Subject: Response to Department Staff's Review Comments on the Juniper Ridge Landfill
Expansion Application, MEDEP #S-020700-WD-BI-N

BGS AND NEWSME'S RESPONSE TO DEP'S JANUARY 22, 2016 TECHNICAL REVIEW LETTER

FIGURE 4-3
ENLARGED PHOTOGRAPHS

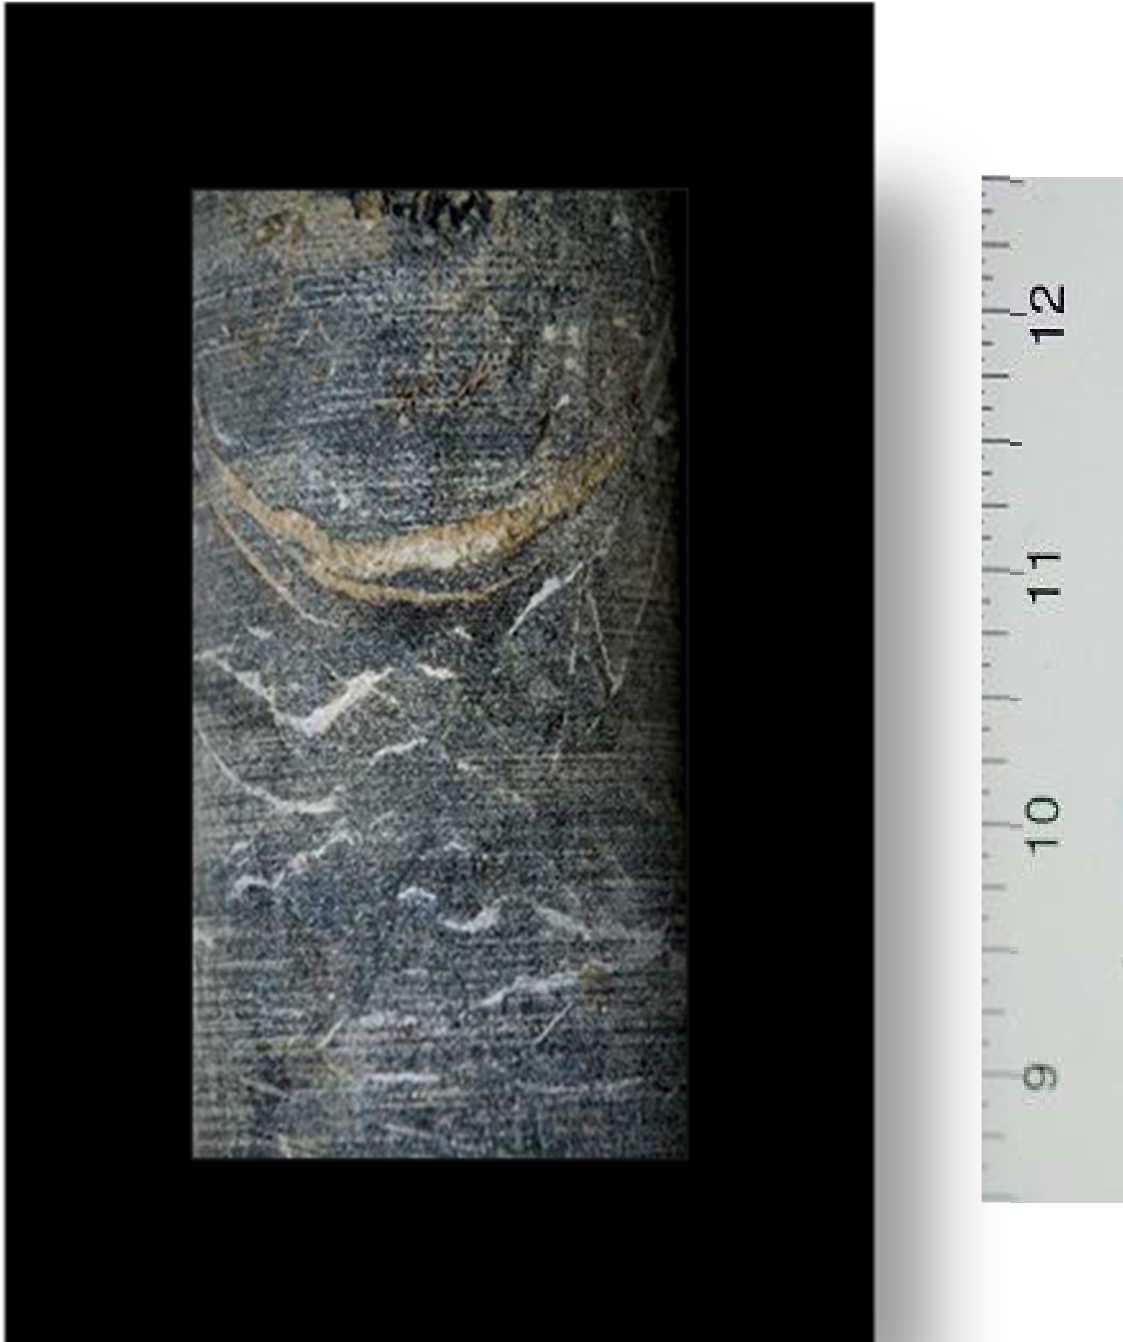
This section includes photographs (Figure 4-3) of the three prominent rock types encountered during the drilling program. Providing photographic documentation is an excellent idea but the photographs are too small and dark to be useful to the reviewer. Larger photographs, perhaps 8" x 10", would provide adequate detail. Larger photos would also permit JRL to annotate the photos with some of the important characteristics (e.g., foliation, calcite and quartz veins, relic bedding and fractures).
